Modification of Development Consent

The development consent (SSD 5581) for the Airly Mine Extension Project, granted by the Planning Assessment Commission, as delegate of the Minister for Planning, on 15 December 2016.

- MOD 5 – *Modification Report 5 – Airly Mine SSD 5581* (dated August 2023), including the associated Response to Submissions Report (dated 27 October 2023) and additional information dated 20 September 2023.
- Replace all references to “DoEE” with “DCCEEW”.
- Replace all references to “Heritage Division” with “Heritage NSW”.
- Replace all references to “Secretary” with “Planning Secretary”.
- Replace all references to “RMS” with “TfNSW”.
- Replace all references to “the Water Division” with “DPE Water”.
- In condition 7(h) of Schedule 3, delete “condition 27” and replace with “Table 7 of Schedule 4”.
- In condition 7(x) of Schedule 3, delete “Rehabilitation Management Plan” and replace with “Rehabilitation Strategy”.

Figure 3A: Mining schedule

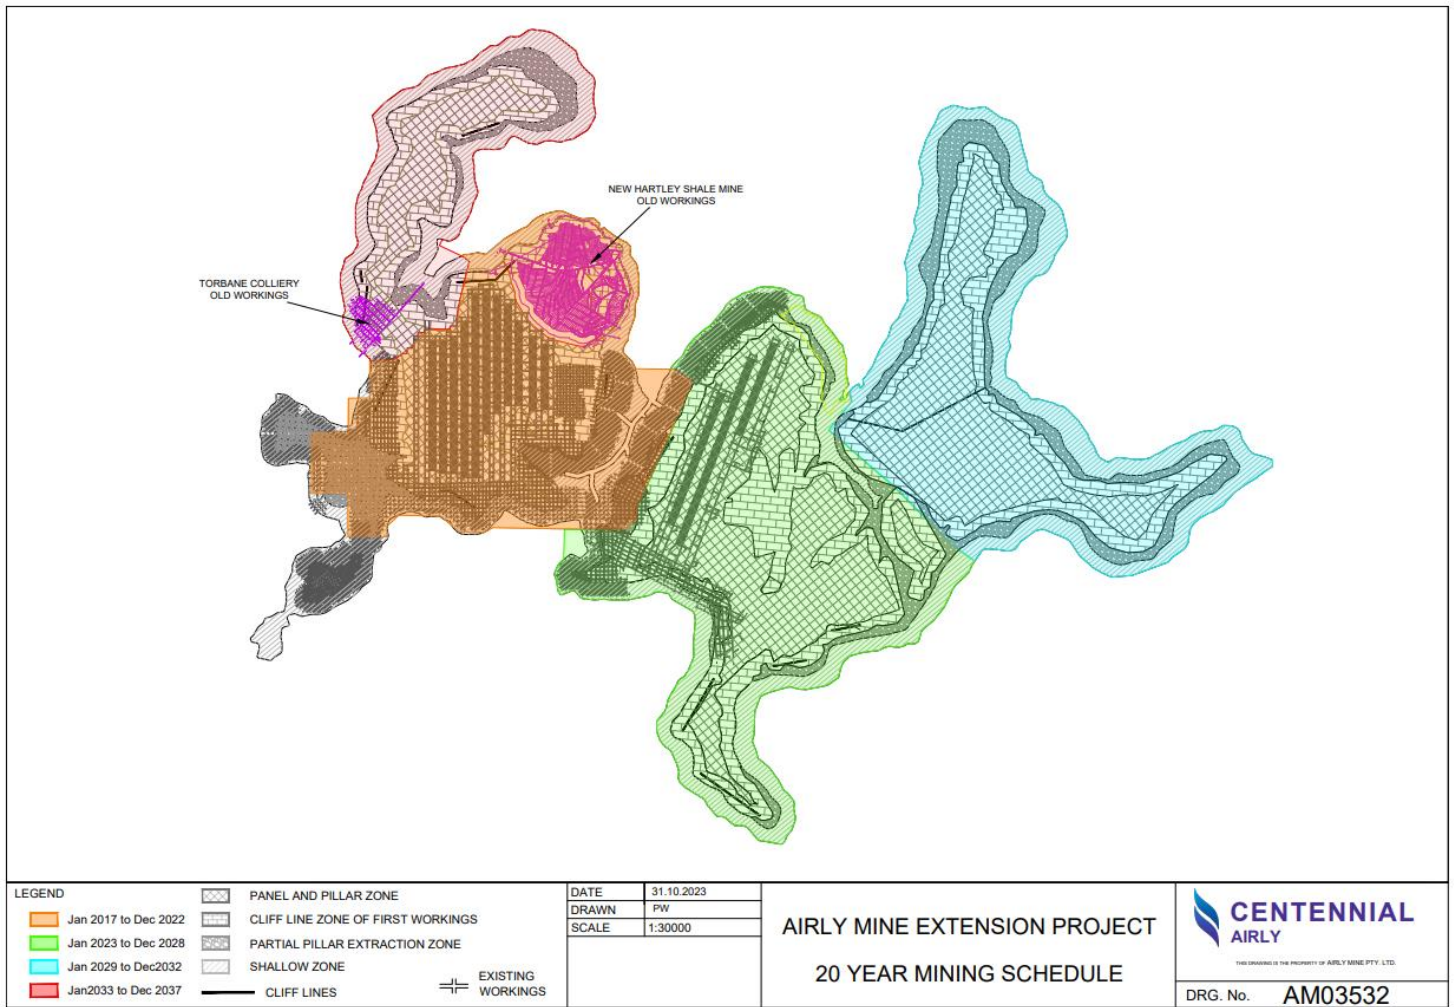
15. After Figure 3 in Appendix 3 insert the following figure:
